Construction Compound Plan (CCP) – Eram Park

Document number:	NEL-EST-NEA-6990-EPA-PLN-0001
Revision date:	18/11/2025
Revision:	01

B-1 FIEA Verification

Figure 4 Locational Context of the Eram Park Compound

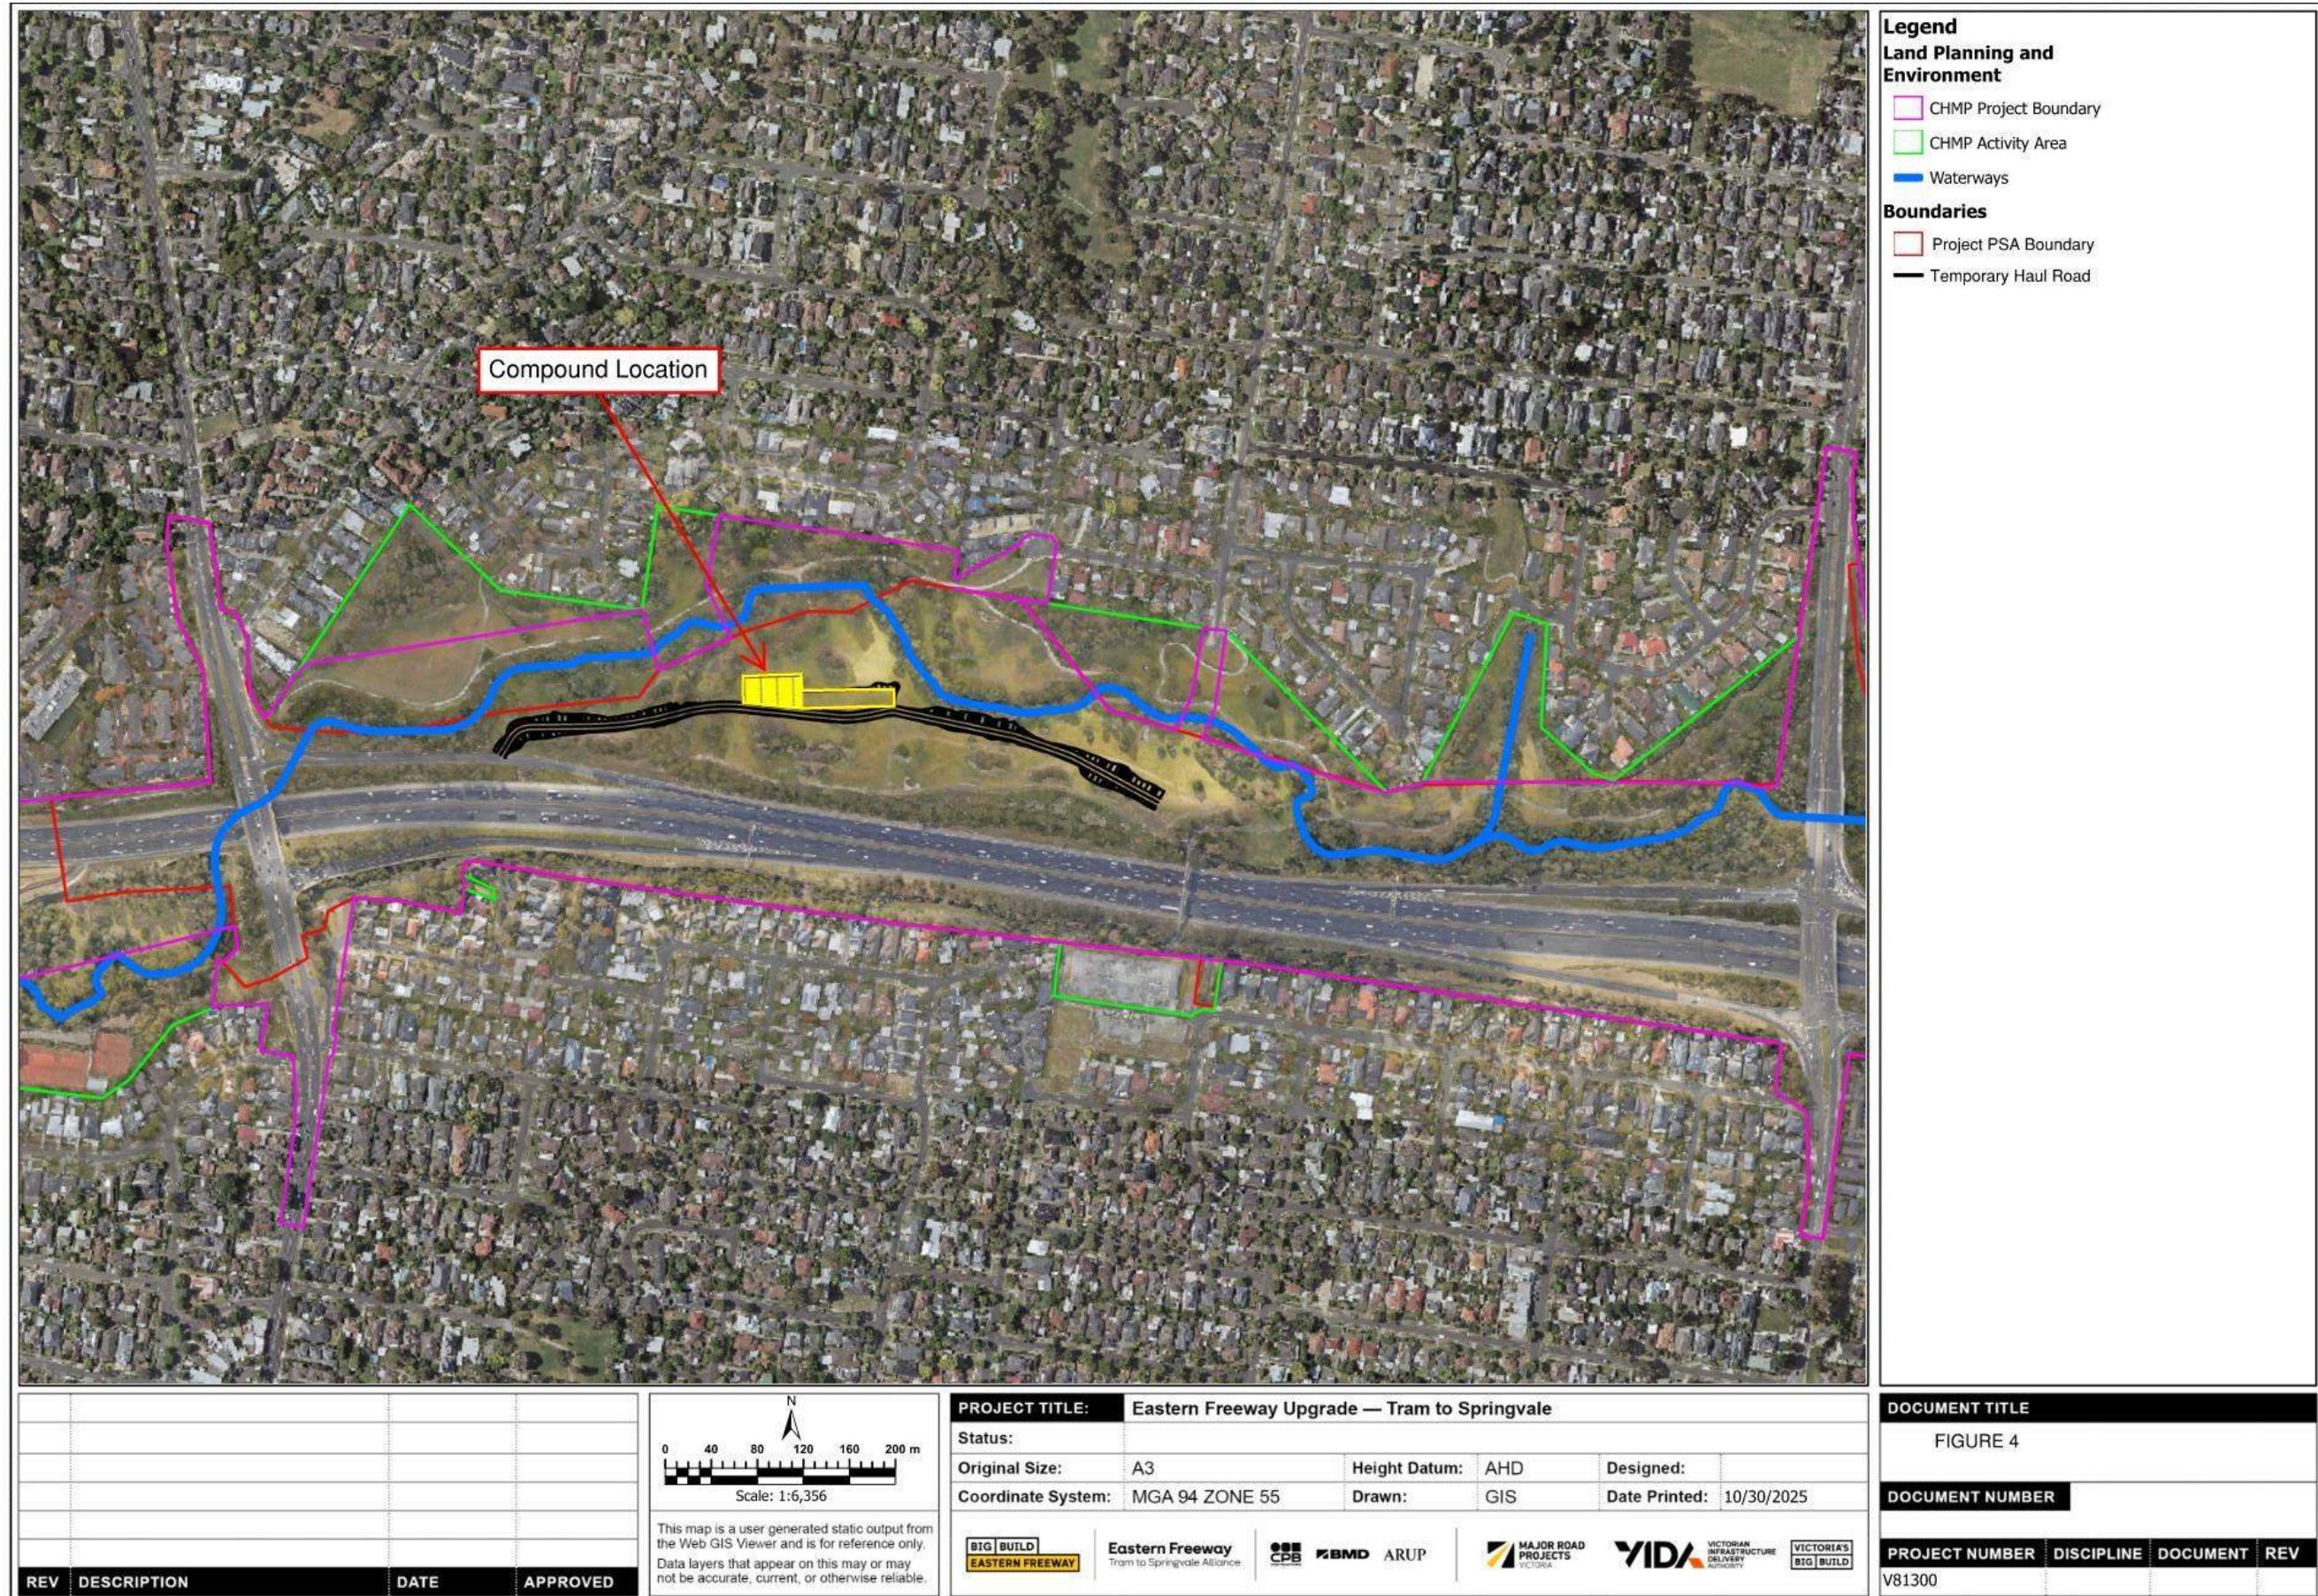
N/A	NEL-EST-FIEA-6990-EPA-CRS-0001	B	N/A	09.01	NEL-EST-NEA-6990-EPA-MPL-0001	N	Eastern Freeway: Tram to Springvale Alliance	Comment noted, reference updated.	NELP Incorporated Document Dec 2019 amended Sept 2023	21-07-25	D	N/A	LPE	O	N/A
N/A	NEL-EST-FIEA-6990-EPA-CRS-0001	B	N/A	09.01.01	NEL-EST-NEA-6990-EPA-MPL-0001	N	Freeways IEA	FIEA comments addressed	NELP Incorporated Document Dec 2019 amended Sept 2023	08-08-25	D	N/A	LPE	C	N/A
N/A	NEL-EST-FIEA-6990-EPA-CRS-0001	B	N/A	10	NEL-EST-NEA-6990-EPA-MPL-0001	N	Freeways IEA	The FIEA notes that Figure 5: (indicative) layout of Eram Park Compound site Legend indicates a thick red line for the Project PSA boundary. However there is an additional thin red line which runs somewhat parallel to the compound mains Connection (proposed) and across the site. Please clarify what the thin red line refers to and update the site legend accordingly as red has been used to represent 2 (Two) different types of information in the figure.	General	14-07-25	D	N/A	LPE	O	Yes

N/A	NEL-EST-FIEA-6990-EPA-CRS-0001	B	N/A	10.01	NEL-EST-NEA-6990-EPA-MPL-0001	N	Eastern Freeway: Tram to Springvale Alliance	Comment noted, figure updated.	General	21-07-25	D	N/A	LPE	O	N/A
N/A	NEL-EST-FIEA-6990-EPA-CRS-0001	B	N/A	10.01.01	NEL-EST-NEA-6990-EPA-MPL-0001	N	Freeways IEA	FIEA comments addressed	General	08-08-25	D	N/A	LPE	C	N/A
N/A	NEL-EST-FIEA-6990-EPA-CRS-0001	B	N/A	11	NEL-EST-NEA-6990-EPA-MPL-0001	N	Freeways IEA	The FIEA notes that Figure 5: (indicative) layout of Eram Park Compound site Legend indicates a thick pink line for the Site temporary fencing. However a different pink symbol and line combination has been used in Figure 5. Please clarify and update the site legend accordingly.	General	14-07-25	D	N/A	LPE	O	Yes
N/A	NEL-EST-FIEA-6990-EPA-CRS-0001	B	N/A	11.01	NEL-EST-NEA-6990-EPA-MPL-0001	N	Eastern Freeway: Tram to Springvale Alliance	Comment noted, figure updated.	General	21-07-25	D	N/A	LPE	O	N/A
